Docket Item #4 & #5  
BAR CASE # 2017-00057 &  
2017-00080

BAR Meeting  
April 19, 2017

**ISSUE:** Permit to Demolish and Certificate of Appropriateness for Addition,  
Alterations and Waiver of Rooftop HVAC Screening Requirement

**LOCATION:** 907 King Street

Figure 1. View of existing conditions (left) and revised design (right) from North Alfred Street.

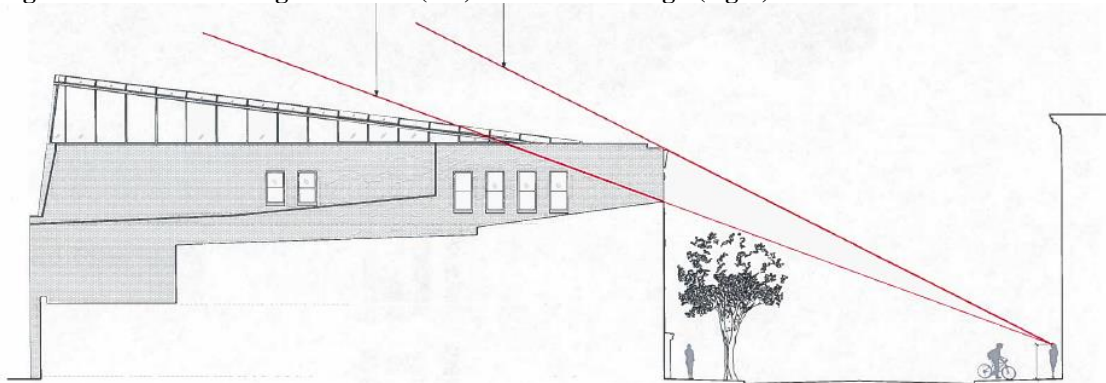
Staff is extremely supportive of the revisions since the previous BAR review and finds that many of the BAR's comments and concerns have been satisfied. The rear elevation has been subdued with respect to fenestration detailing and window frame system color and, while still simple and contemporary, no longer presents a jarring contrast to the historic building and its historic context (Figures 4&5). The revised third floor glass window wall on the rear now has the form of a traditional batten-seam mansard roof, which is the form that was also used very successfully on the addition to the historic red brick Victorian townhouse whose roof is, unfortunately, just out of view to the right in Figure 1.

The overall size and design of the skylight above the stairway has now been significantly reduced to ensure that it is not visible from any perspective from King Street and to better integrate with the building as a whole (Figures 2, 3, 4 and 5). Additionally, the applicant addressed the BAR's comments regarding the front elevation by creating a more balanced and cohesive storefront area.

*Figure 1: Potential sight-lines from King Street, looking north.  
Courtesy of Studio 27 Architecture.*

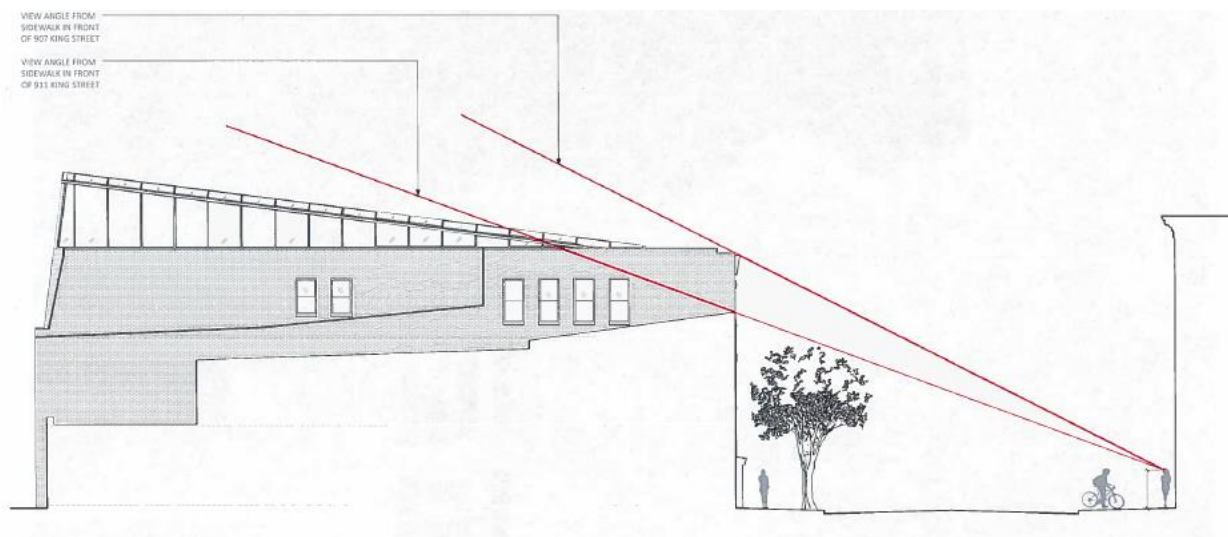
Furthermore, BAR staff is very concerned that this glass skin will emit significant light at night, with the skylight over the stair calling for attention from King Street and the north elevation becoming a beacon on North Alfred Street. BAR staff recommends that the applicant provide a night rendering of the project demonstrating how this light will be mitigated so that the project blends with its surroundings at night.

**Figure 5, left: Conceptual rendering of north (rear) elevation. Note the third-floor curtain wall has three lights.**  
**Figure 6, right: North (rear) elevation. Note the third-floor curtain wall has seven lights.**  
**Courtesy of Studio 27 Architecture**

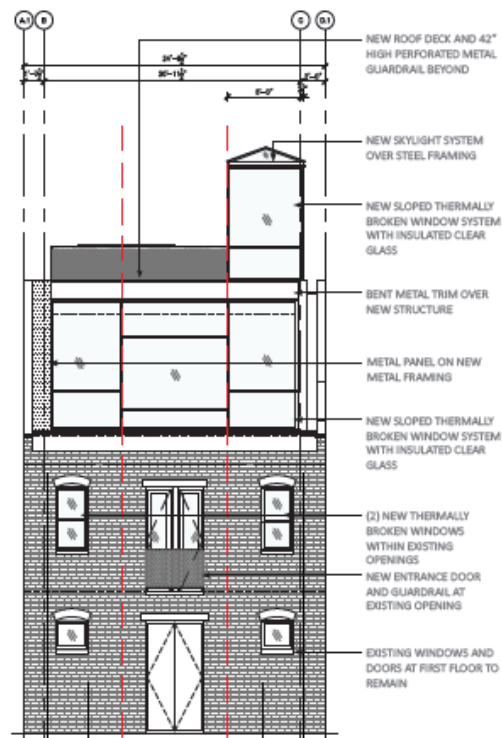
The existing Mansard roof with its centralized, triangular gable window on the third floor of the north elevation will be demolished and replaced by a new sloped window wall with metal framing which will be surrounded by a bent metal trim and a metal panel on the east side. While the conceptual rendering shows only three vertical lights, the elevation appears to depict joints which break the glazing wall into seven irregularly-sized lights. [Figures 5 and 6] The third-story curtain wall will be clearly visible from North Alfred Street.

Although located on the roof and the rear of the building, the rooftop stairwell skylight system and the third-story window wall on the north elevation will be partially visible from King Street and clearly visible from North Alfred Street respectively [Figures 1-3]; therefore, compatibility with the extant building as well as with the historic urban context is a primary concern. The greenhouse-like stairwell element and the curtain wall appear to have been perched atop a historic, masonry building rather than to grow naturally from it, and details which might tie the two volumes (the old with the new) together are lacking. There is no precedent in Old Town for such large expanses of steel and glass on a historic structure. Although the slope of the curtain wall system generally mimics the present Mansard roof, that element is a late 20<sup>th</sup>-century addition that has little design relationship with the 19<sup>th</sup>-century core atop which it sits. While the metal-seam roof punctuated by a Post-Modern style, triangular, multi-light gable window has nothing in common with the rest of the building's fabric, and is slightly high-style for an alley elevation, it is at least benign and does not shout for attention. The side walls of that 1983 third-story addition are composed of bricks which successfully blend with the historic fabric and the roof is clad with grey colored standing seam metal that also blends with its surroundings.

*Figure 7: Standard window detail.  
Courtesy of Studio 27 Architecture*

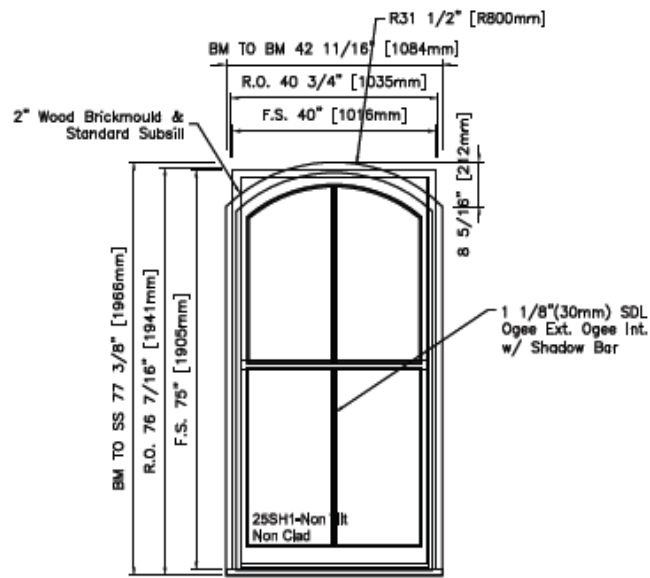
While staff was previously concerned that the original design was neither well integrated nor in a positive dialogue with the 19<sup>th</sup>-century fabric of 907 King Street; the revised scheme represents a much better coordination between the new and the old, effectively showing how new and untried design approaches can be successfully integrated into the historic district. Staff asked whether the proposed glass would have a tint or reflective quality in order to control heat gain and temperature in the building and the applicant has indicated that the glass will meet the standard reflectivity/light transmittance values noted in the Window Policy.
